Well Name : Marquez A2  
API # : 007-06327

Photo 1: Wellhead sign at turn off from CR.

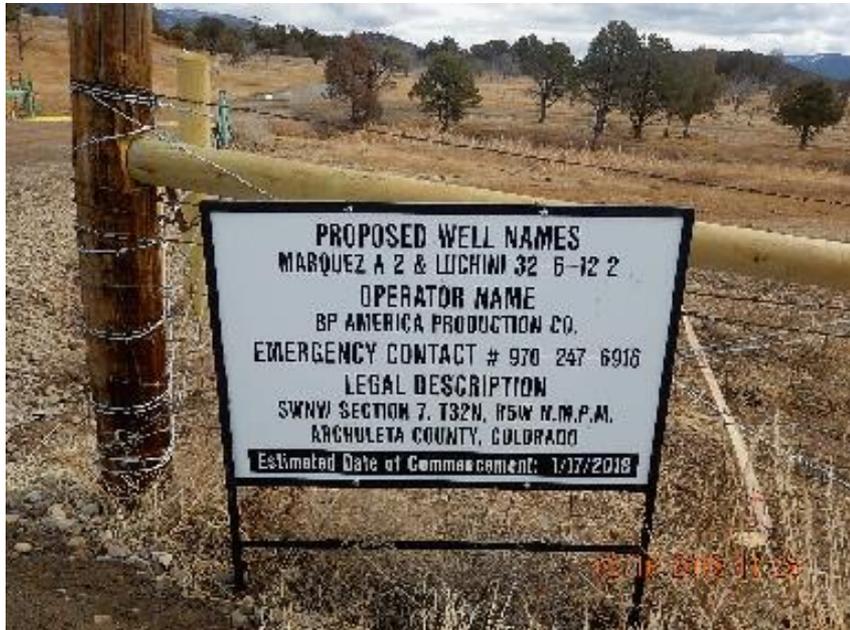
Photo 2: Erosion control waddle in SW corner not trenched in, not back filled, and improperly staked.
